ENGINEERING DIRECTIVE

Revised and Updated Construction Standard Details

The purpose of this Engineering Directive is to revise and update certain drawings contained in the *Construction Standard Details*, as follows:

E 106.3.0R

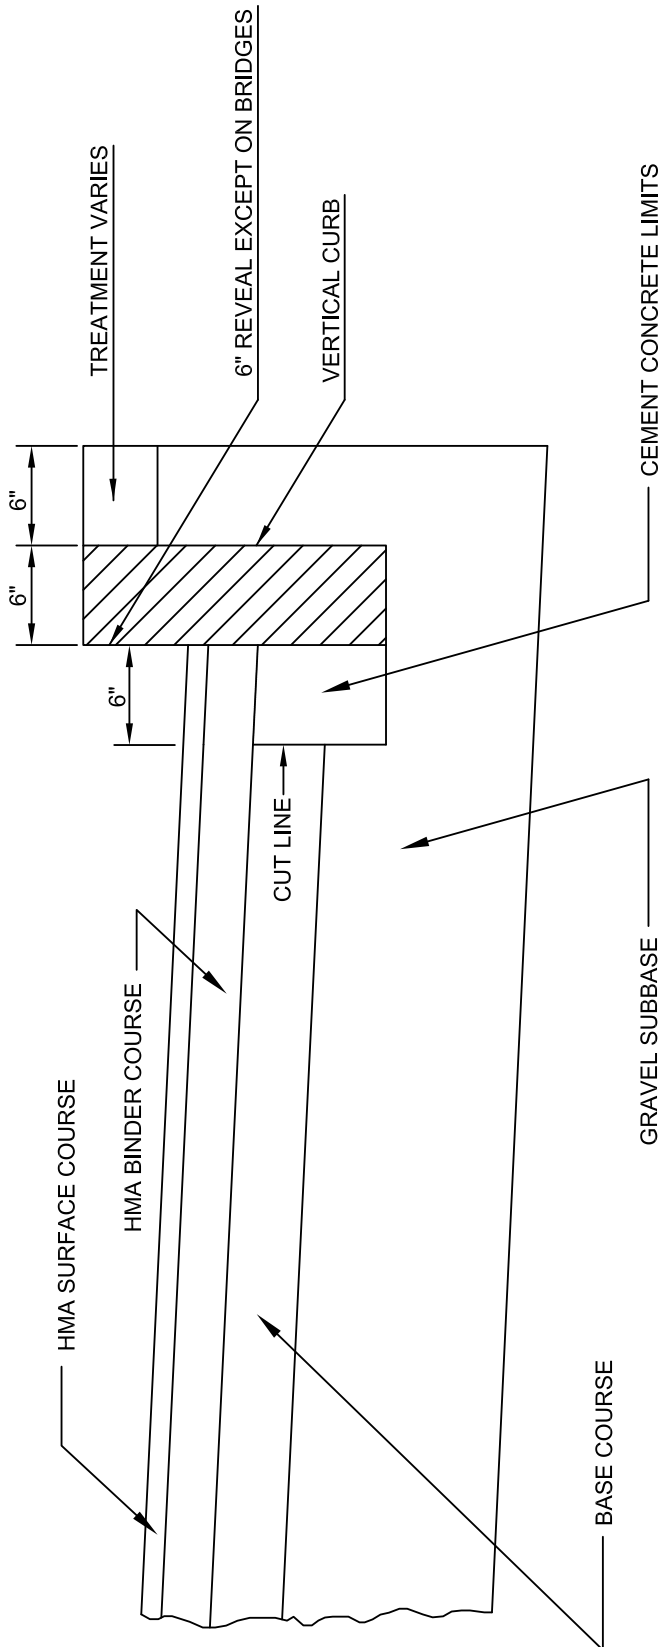
New Drawing Number and Date	Replaces Drawing Number and Date	Drawing Title	Change
E 106.3.0R March 2012	E 106.3.0 August 2010	Method of Setting Vertical Curb	Extends the HMA Binder Course to the curb to help prevent surface cracking along the cut line.
E 201.3.0R March 2012	E 201.3.0 August 2010	Concrete Block Catch Basin	Standard Depth error 9'-6" corrected to 6'-6".
E 202.6.0R March 2012	E 202.6.0 August 2010	Manhole Frame and Cover – A Frame	Dimension Arrows extended from border to outside edge of standard cover drawing indicating a 26-inch overall diameter manhole cover.
E 401.2.0R March 2012	E 401.2.0 August 2010	Installation For Steel W Beam Highway Guard for Sign Protection	Deletion of Note 3 referencing back up plates. Approach slope to guard rail indicated.
E 401.5.1R March 2012	E 401.5.1 August 2010	Bridge Rail to Highway Guard Transition	Deletion of Notes 1 and 4. Drawing rescaled to show full length of payment unit. Allows for quicker transition to W Beam guard rail.
